Wisconsin Department of Transportation

Proposal #07: 1060-27-74, WISC 2025597
I-94 East West, Early East Leg
30th Street to 25th Street
IH 94
Milwaukee County

This is Addendum No. 02, which provides for the following:

ADDENDUM NO. 02

Addendum No. 02
ID 1060-27-74
Revised Sheet 124
August 28, 2025

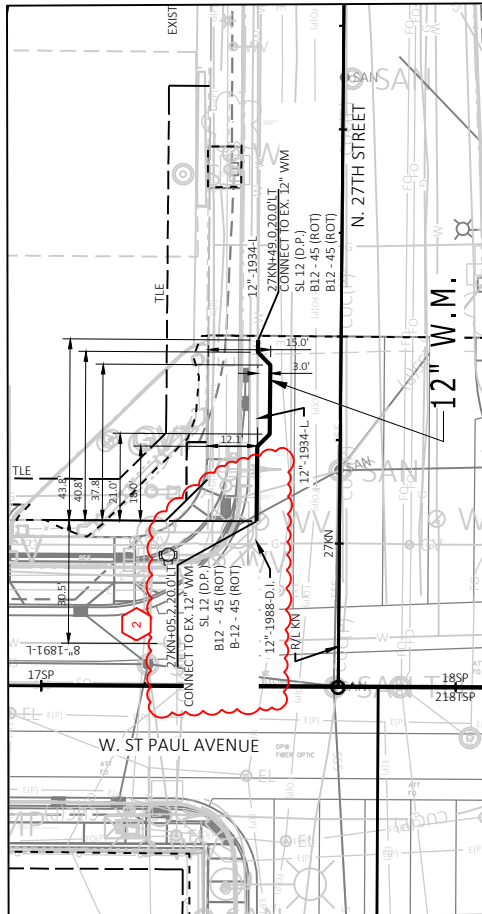
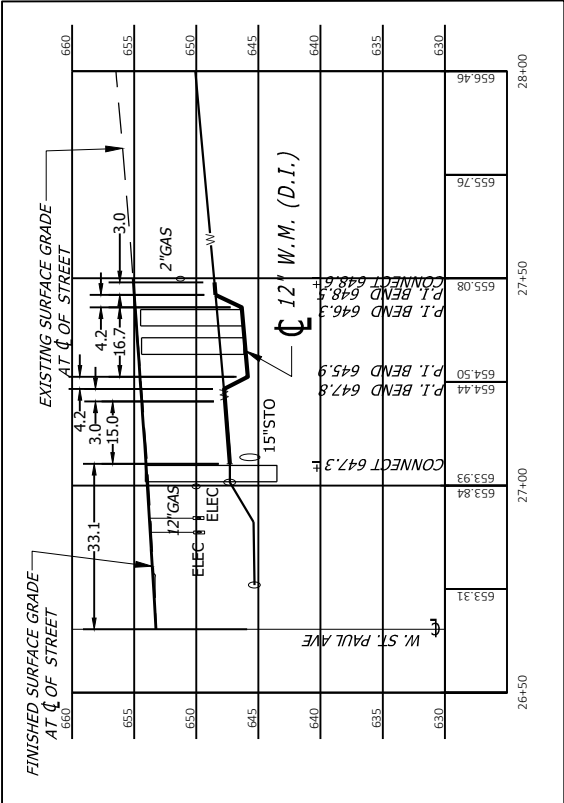
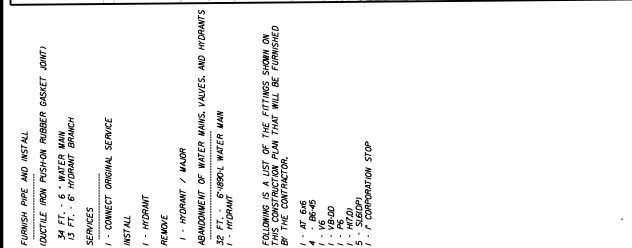
Revised Plan Sheets	
Plan Sheet	Plan Sheet Title (brief description of changes to sheet)
4	General Notes – updated utility contact information
70	Removal Plan – Added callout for Removing Bollard bid item
124	N. 27th Street Watermain – Updated location for proposed 12" water main connection and the 12"water main length, and fittings; updated the MWW Project Number.
125	W. St. Paul Avenue Watermain – Updated the hydrant fitting, MWW Project Number and Plan File Number.
204-205	Lighting Plan – Shifted Pole T-DPH1 east (station/offset updated) and updated conduit type between T-CPH1 and T-DPH2 from overhead to cable-in-duct
217	City Underground Conduit – CUC plan detail with updated construction note and updated a manhole from being adjusted to removed and replaced.
218	City Underground Conduit – CUC plan detail with revised construction notes.
367	Miscellaneous Quantity – Revised Removing Concrete Pavement quantity

Addendum No. 02
ID 1060-27-74
Revised Sheet 217
August 28, 2025

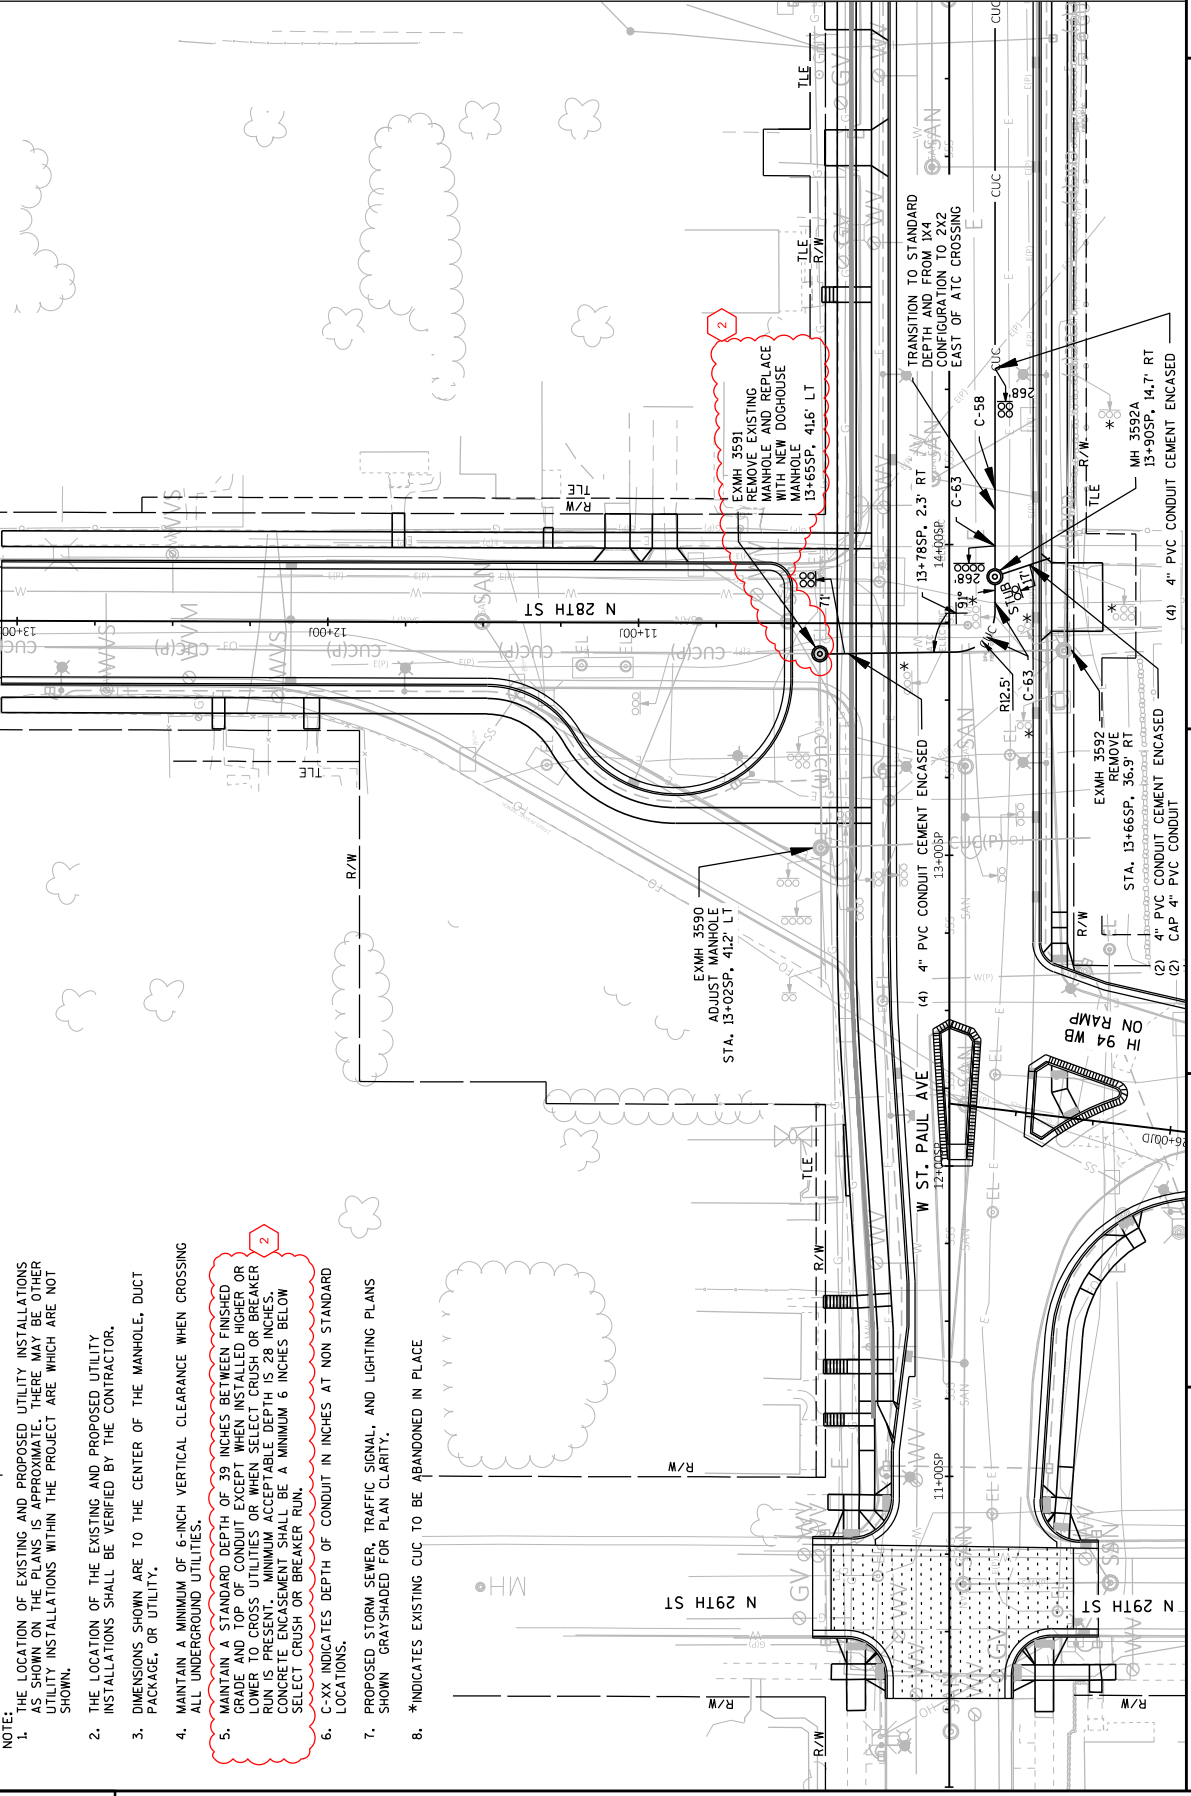
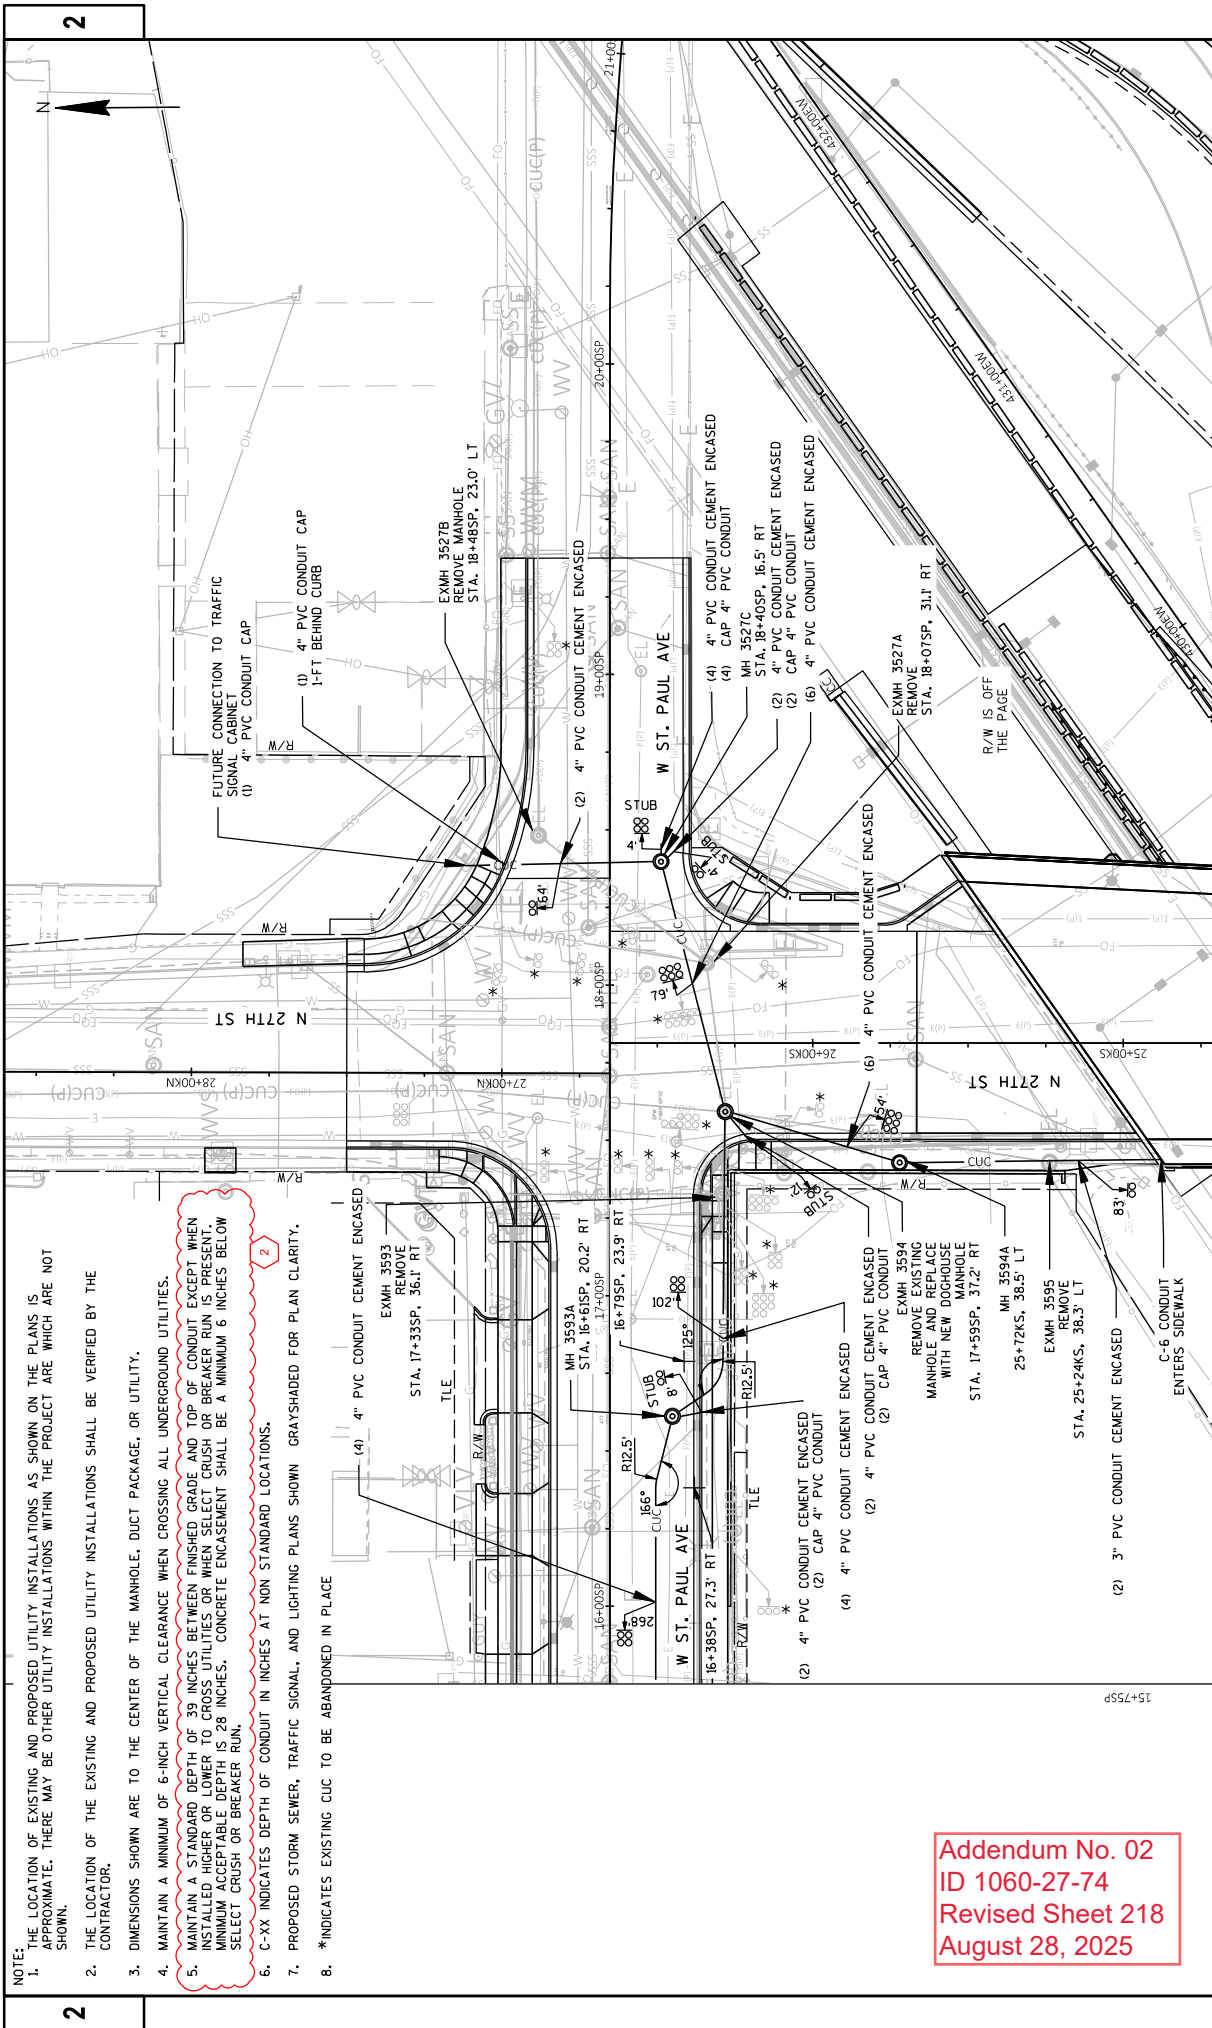
1. COMPLETE SPLICE TO CONNECT EXISTING 10 UDL C/D/PH, CPH25/DPH25, AND CPH26/DPH26 TO DISTRIBUTION CENTER PH.

STATE OF WISCONSIN DEPARTMENT OF TRANSPORTATION	
STRUCTURE R-40-761	
DESIGNED BY	WARRS
CHECKED BY	MTZ LKD
GENERAL NOTES, QUANTITIES & PROFILE GRADE LINES	
SHEET 5 OF 38	
829

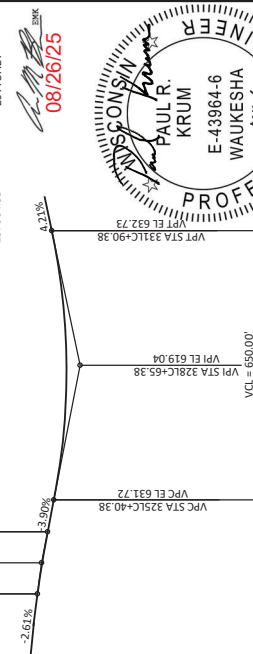
369	Miscellaneous Quantity – Added table for Removing Bollard
413	Miscellaneous Quantities – Revised Temporary Left-In-Place Lighting Conduit and Cable table and STA/OFF of pole T-DPH1.
424	Miscellaneous Quantities – Revised 12" Water main quantity.
425	Miscellaneous Quantities – Revised CUC MQ sheet.
829	Structures Plan (R-40-761) – Revised Timber Lagging quantity.
846	Structures Plan (R-40-761) – Added optional construction joint note.
